## **CITY OF POUGHKEEPSIE POUGHKEEPSIE, NEW YORK**

### **Replacement of Two (2) Reservoir Tanks at College Hill RFB COP 04-16-01**

# **ADDENDUM NO. 2**

**July 1, 2016**

PROJECT NUMBER	12422.02
C	201
DRAWING NUMBER

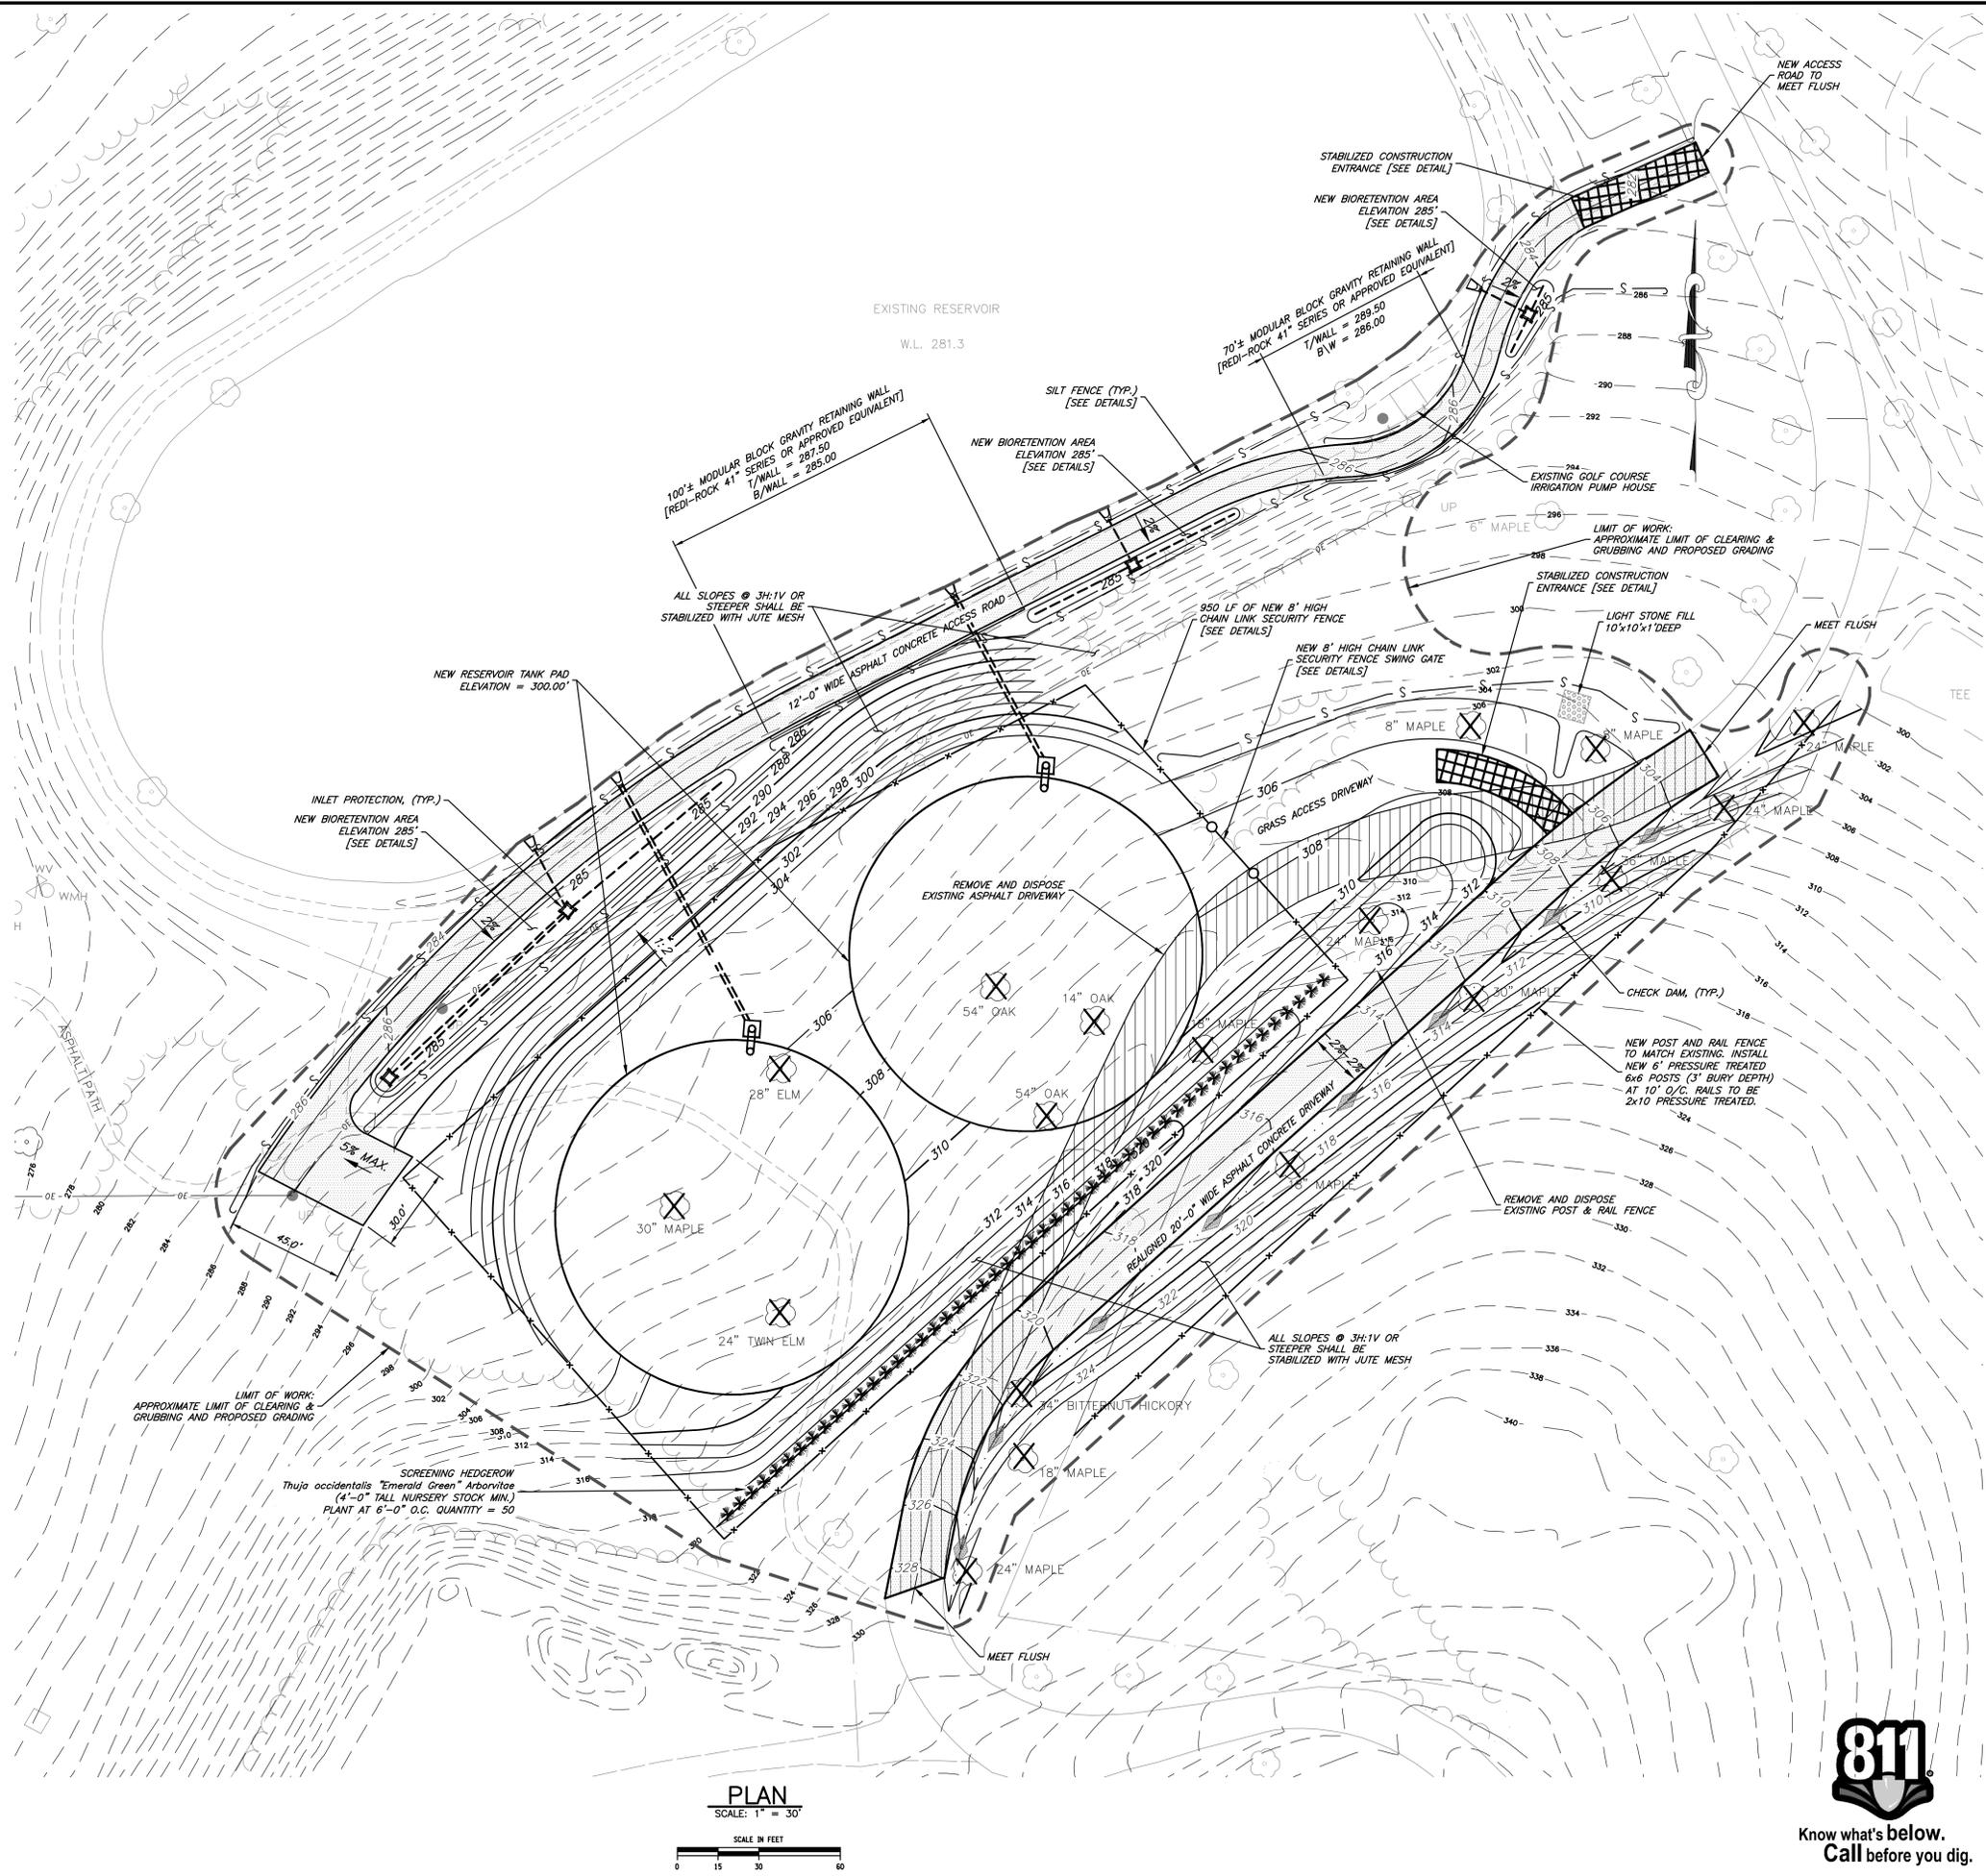
- Can you please verify the extent of tree/stump removals and clearing and grubbing as applicable?

**A revised Grading Plan is included in the attached bid set. Line work has been added to show the limits tree/stump removals and clearing and grubbing.**

PROJECT NUMBER  
 12422.02  
**C**  
**202**  
 DRAWING NUMBER

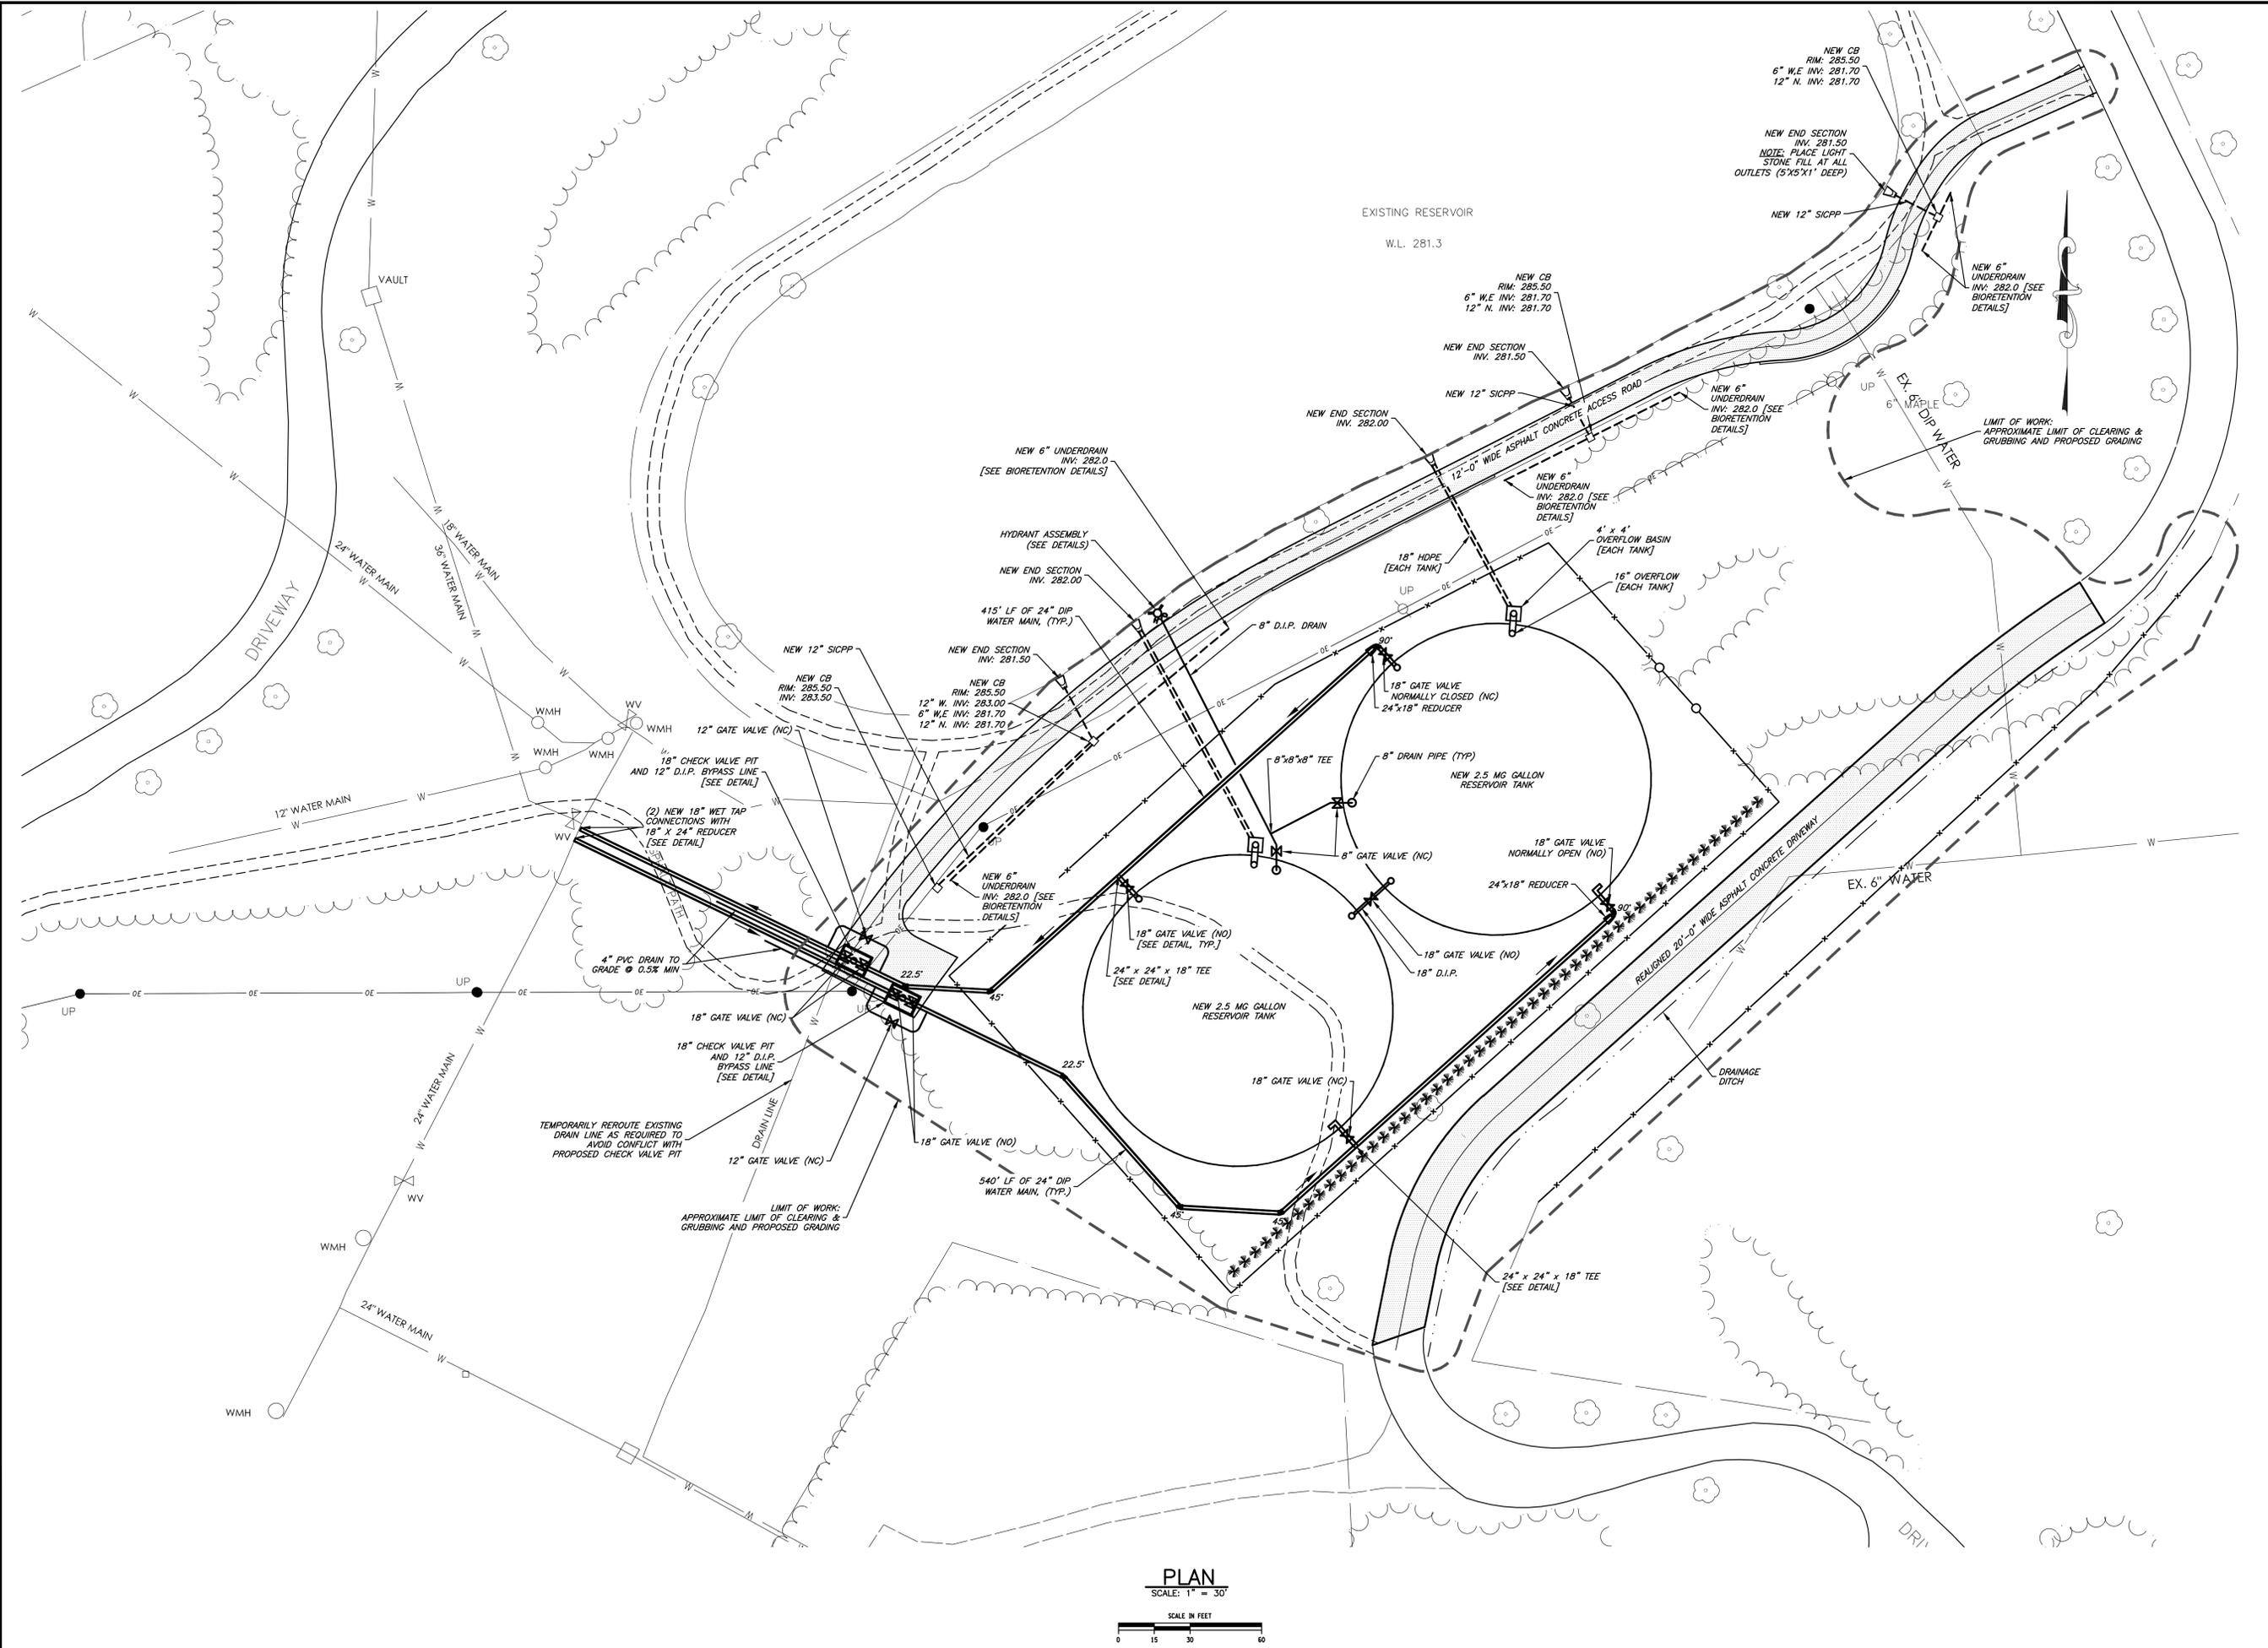
- Can prints of the Utility Plan C 202 be provided without the asphalt shading so that the pipe alignments are not obscured by the dark hatch?

- Overflow Basins- The plan sheet C202 refers to them as 4' x 4', but no Rim & Invert elevations are provided. Plan sheet C804 show a cross section of the tank overflows but does not provide Rims & Inverts. Also, it does not describe the type or size grate required. Please advise on Rim & Inverts and Type or Size Grate required.

- Please remove shading on the utility plan so we can see the layout of the vaults.

**Revised bid set with grayscale hatching is attached.**

**Invert elevation is shown on C804. Rim elevation is 305.**

**A revised drawing set is included with hatching (shading) in grey scale.**

**TAPPING SLEEVE & VALVE DETAIL**

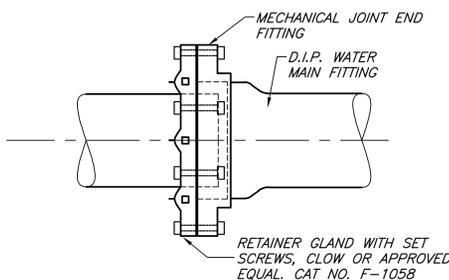
- Specs call for Mueller H-615 MJ Sleeve, also calling for epoxy coating and AIS complaint. Mueller H-615 sleeves are not AIS Complaint nor are they epoxy coated. Please clarify if we are to stick with Mueller’s normal sleeve or go with an AIS complaint epoxy coated sleeve.

**We are researching this item and an answer will be forthcoming in a subsequent addendum.**

**8' CHAIN LINK FENCE**  
N.T.S.

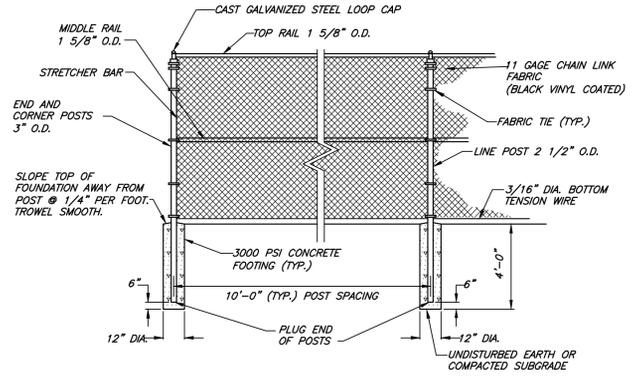
- Please provide a specification for the proposed chain link fence that is to be installed.

**A specification for chain link fence is attached.**

PROJECT NUMBER  
 12422.02  
**C**  
**804**  
 DRAWING NUMBER

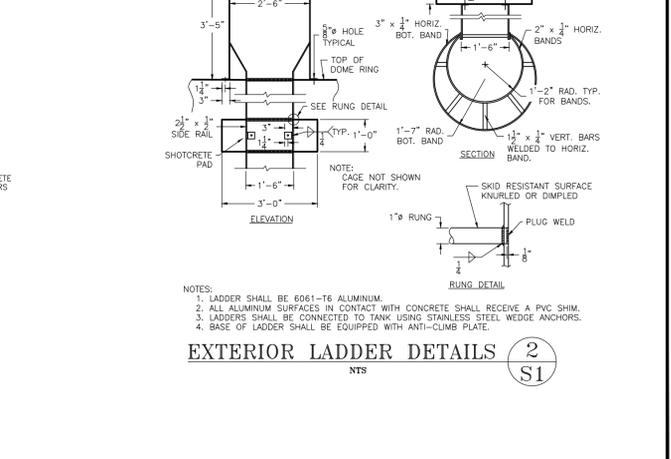
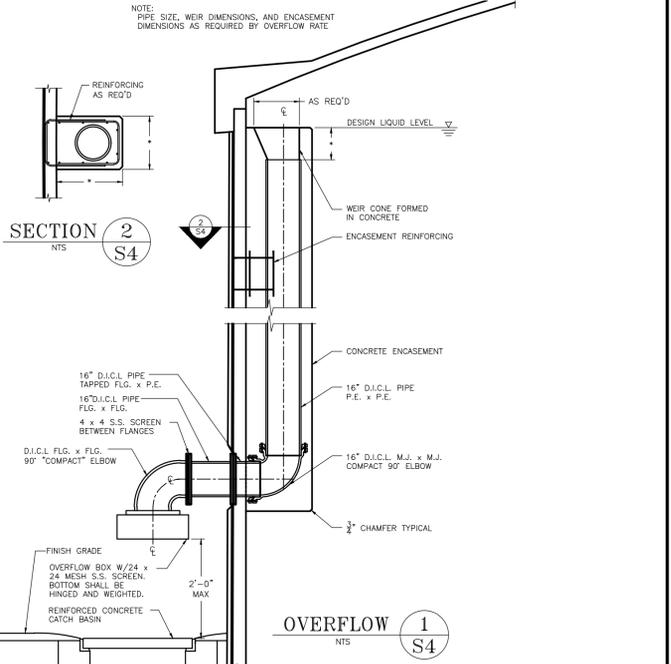
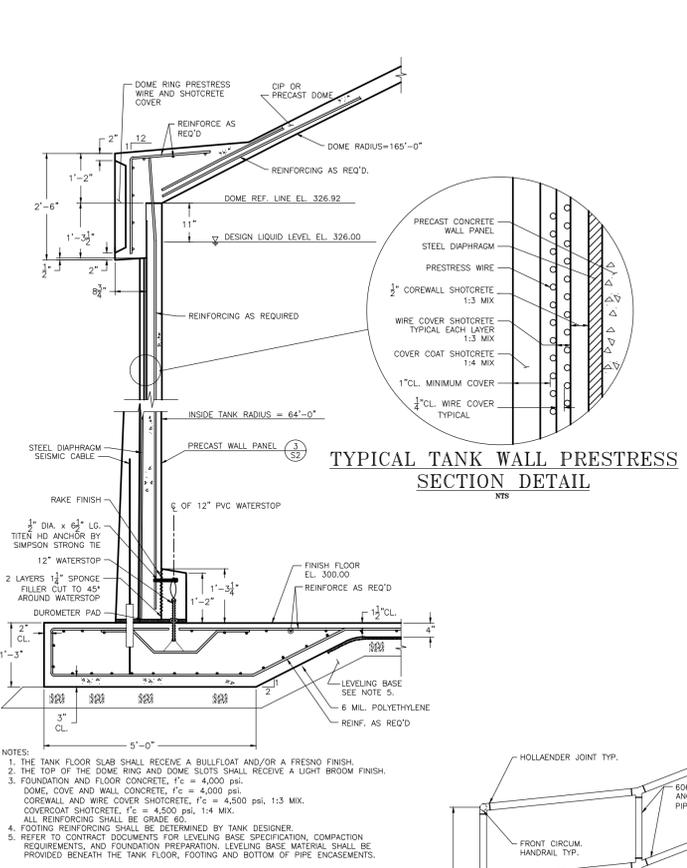
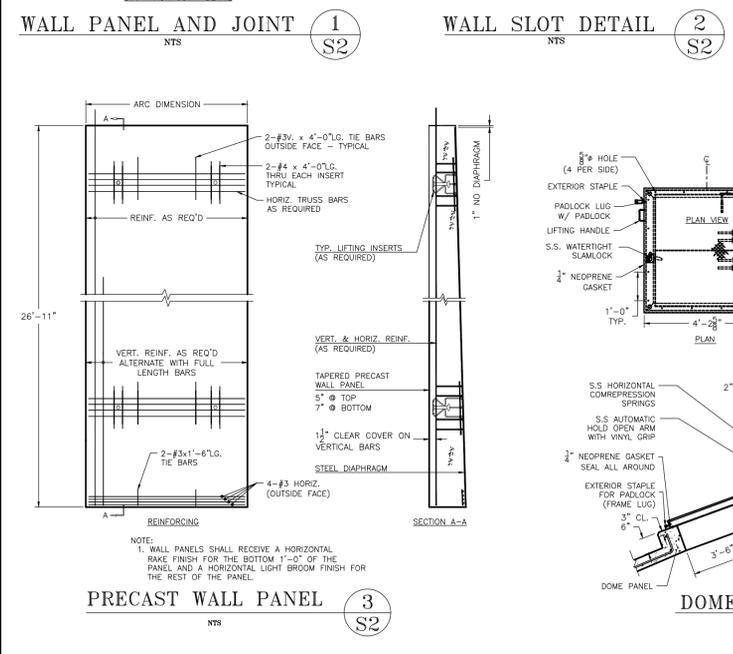
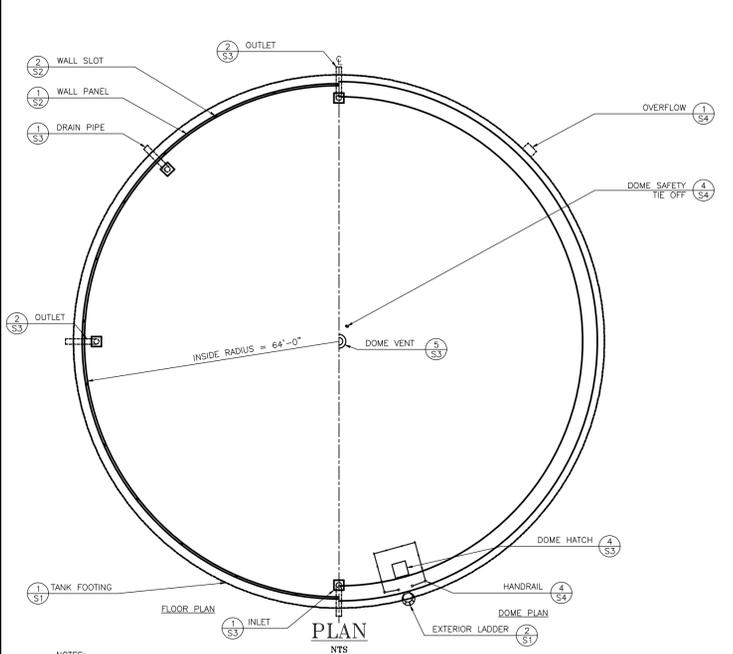
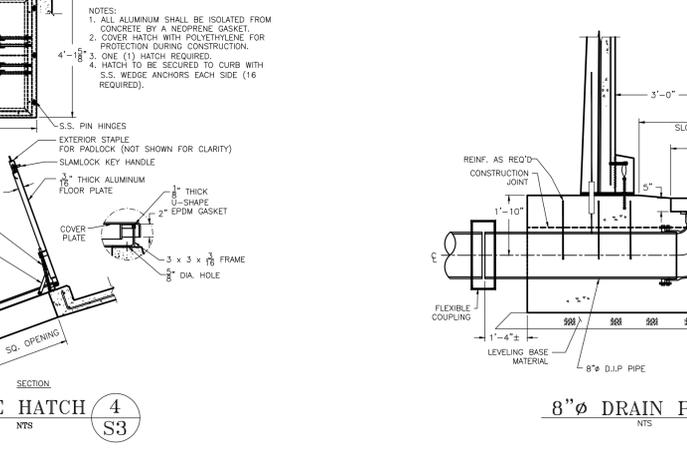
- Section 13000 WIRE OR STAND WOUND PRESTRESSED CONCRETE TANK - Paragraphs 2.10 APPURTENANCES - This paragraph makes no mention of an interior ladder and none is shown on Drawing C 804. Please confirm that no interior ladder is required.

- Section 13000 WIRE OR STAND WOUND PRESTRESSED CONCRETE TANK - Paragraphs 2.10 APPURTENANCES - This paragraph makes no mention of an exterior ladder, however, an exterior ladder is shown and detailed on Drawing C 804. Please confirm that an exterior ladder is, in fact, required.

- Drawing C 804 – PLAN view details two 18” Outlet Pipes [at 9 o’clock and 12 o’clock] plus an 8” Drain Pipe [between 10 o’clock and 11 o’clock]. Please confirm that all these pipe penetrations are, in fact, required.

- The hatch door has three different specs depending on where you look. The spec sheet has a JD-4AL (60”x60”) with 300 psf loading, the plan view shows a 42”x60” opening in the roof, and the section view labels it as a JD-2AL H20 load (48”x48”). Do you know which is correct?

- Drawing No. C804, detail 1/S3 (18” inlet pipe) calls out an MJ x MJ compact 45 degree bend above the tank finish floor. Please confirm if a flanged 45 degree bend would be acceptable alternative to the MJ fitting.

- Drawing No. C804, detail 1/S4 (Overflow) shows the catch basin with an invert elevation of 298.00 which is 2 feet below the tank foundation. Please confirm the catch basin structure can be relocated away from the tanks in order to prevent undermining the tank foundation during catch basin installation. Rip rap or a reinforced splash pad can be provided to divert the overflow discharge from the wall penetration to the catch basin.

**No interior Ladder is required.**

**Yes**

**Provide Model J-5ALH20 by Bilco. See attached Detail**

**Yes, this will be an acceptable alternative.**

**We are researching this item and an answer will be forthcoming in a subsequent addendum.**
